ADDENDUM NO. 1

Project: **LED Conversion – Phase 1**
NC State University
CVM Main Building
1060 William Moore Drive
Raleigh, NC
SCO Project ID: 22-24921-01A
NCSU Project No. 202220014
Building No. 301
SKA Project No. 230114.0

Addendum Date: **June 17, 2024**

Submitted By: **SKA Consulting Engineers, Inc.**

1 LAYDOWN AREA PLAN
E.1.1 NO SCALE
Dwg # 230114-E5200.DWG

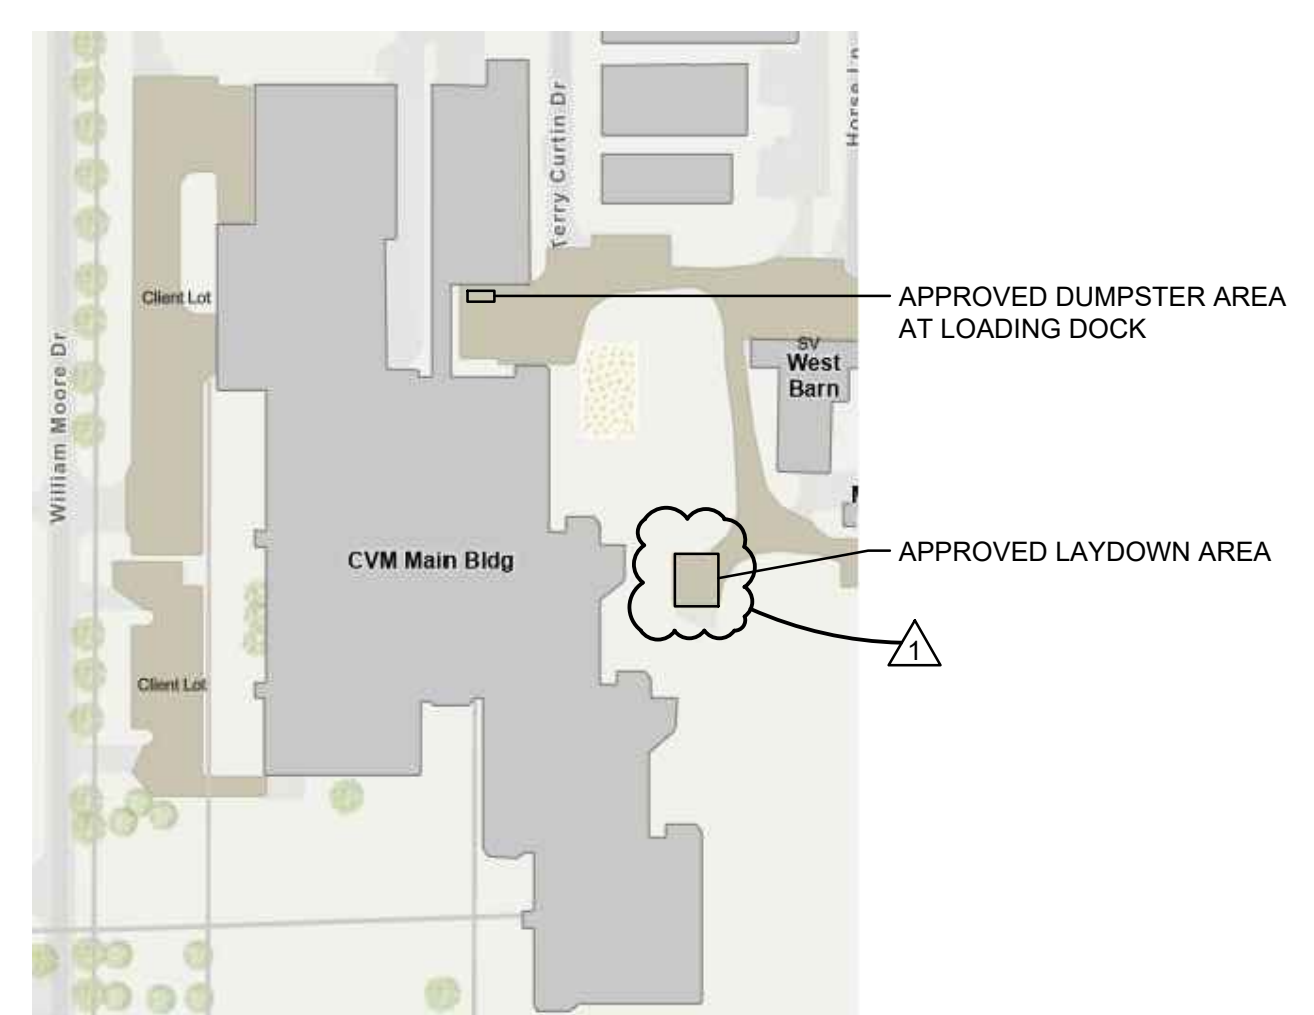
E1.1 Symbol Legend, Abbreviations, and additional specifications – Revised laydown area indicated on Laydown Area Plan.

LIGHTING FIXTURE SCHEDULE

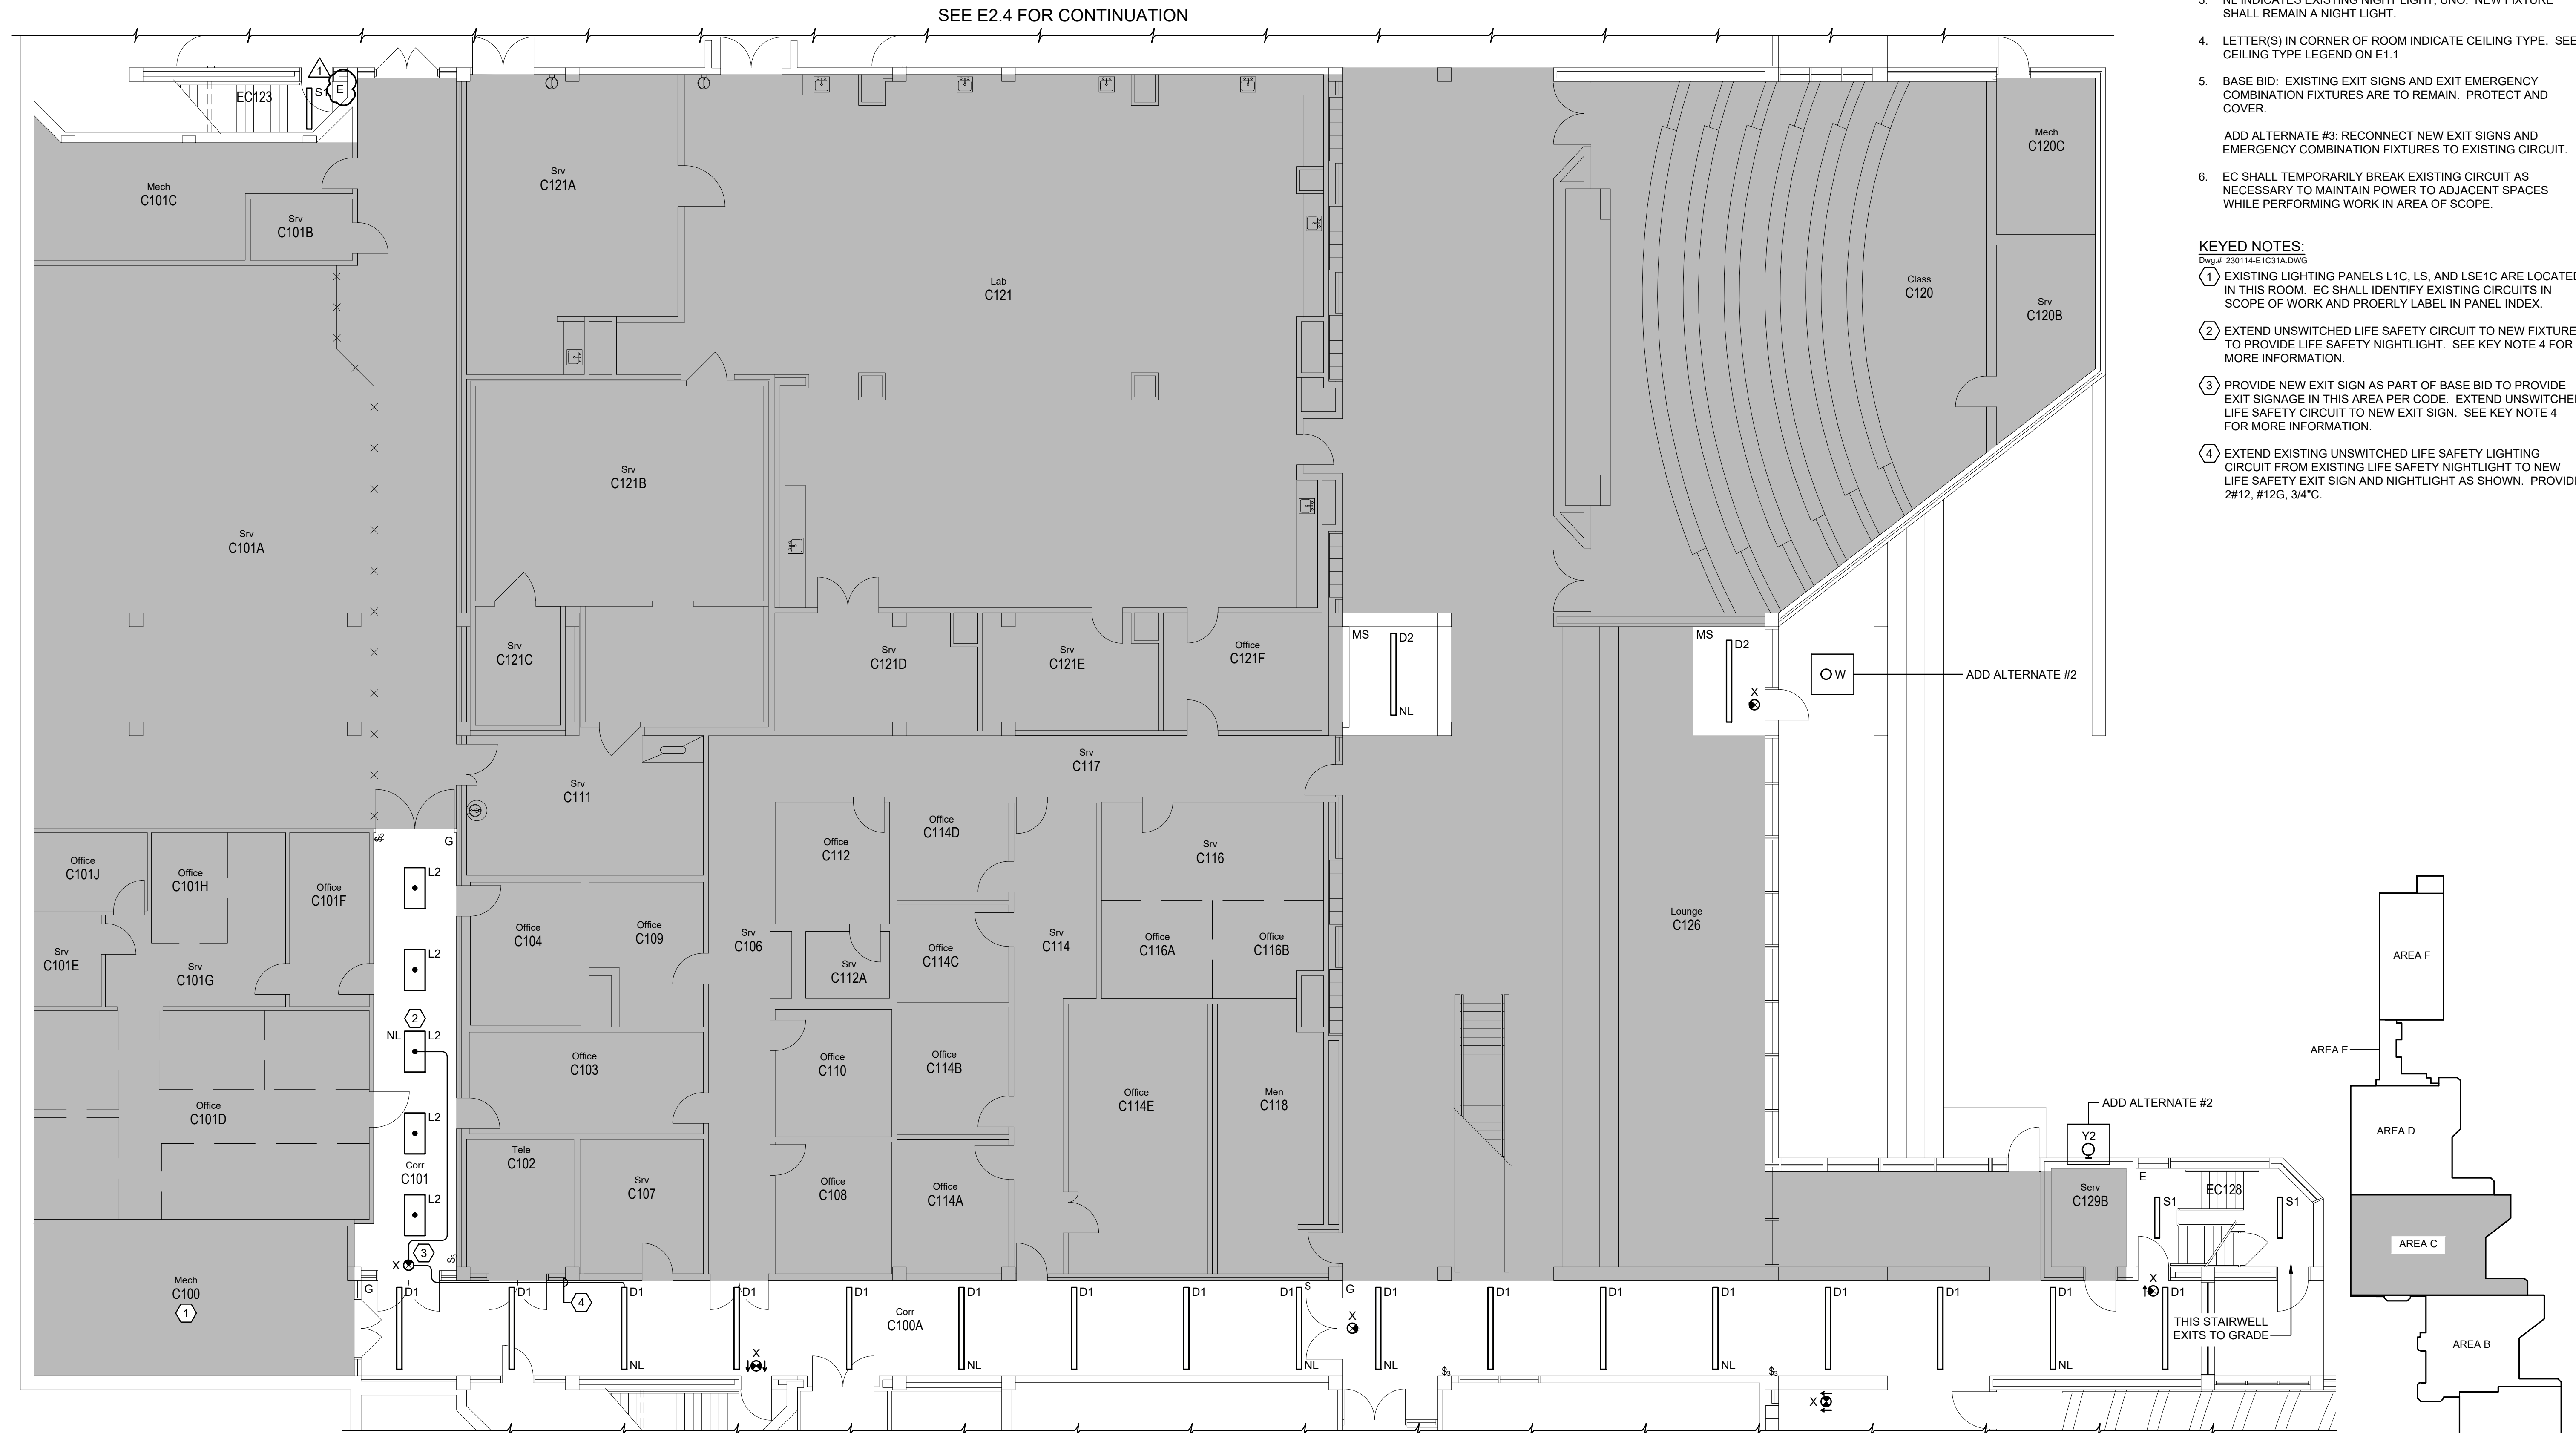
E1.2 Lighting Fixture Schedule – Revised additional electrical notes.

1 PARTIAL FIRST FLOOR - AREA E LIGHTING PLAN
E2.5
1/8" = 1'-0"
Dwg # 230114-E3E31A.DWG
8' 0' 8' 16'

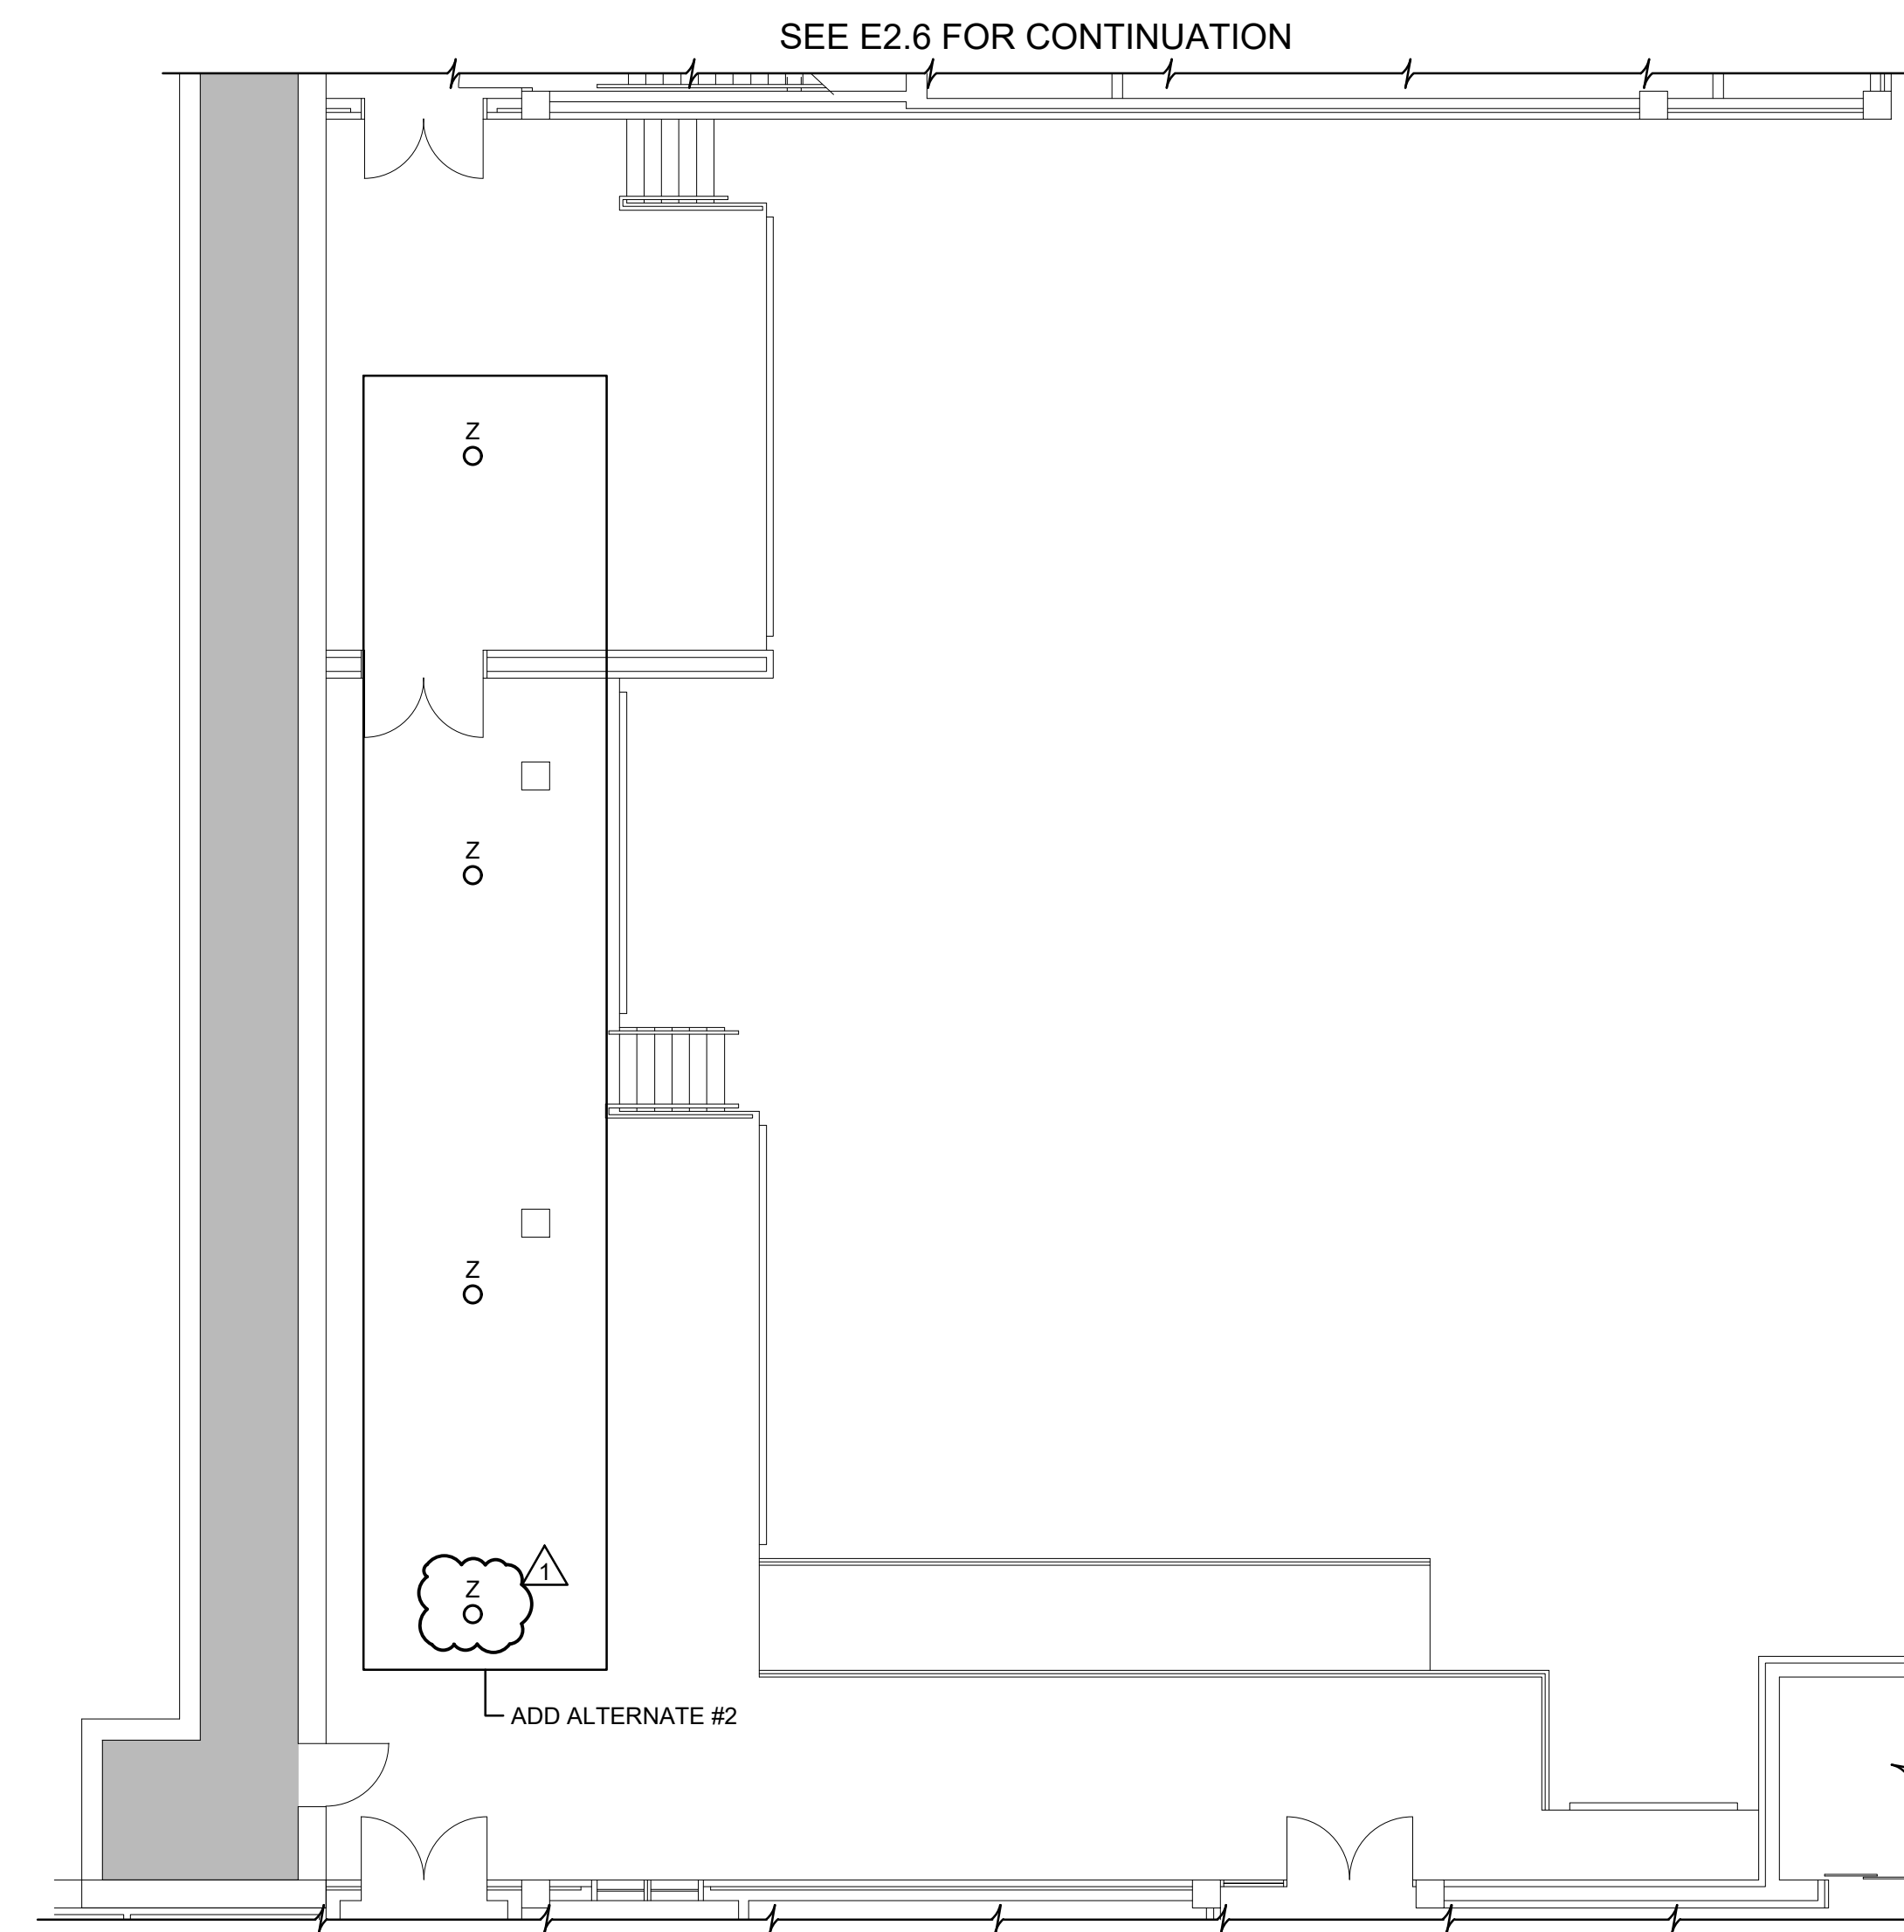
RFI -10 *RFI: Is it in the contractor's scope to provide a new fixture at the loading dock where the existing fixture is currently removed?*

E2.5 Partial First Floor Area E Lighting Plan – Added additional Type Z fixture to plans.

SKA Response: An additional Type Z fixture has been added to the drawings at the loading dock where the existing light fixture outlet box is located.

- 1 PROVIDE NEW FIXTURE AT EXISTING LIGHT FIXTURE OUTLET BOX. RECONNECT NEW LIGHT FIXTURE TO EXISTING LIGHT FIXTURE CIRCUIT.
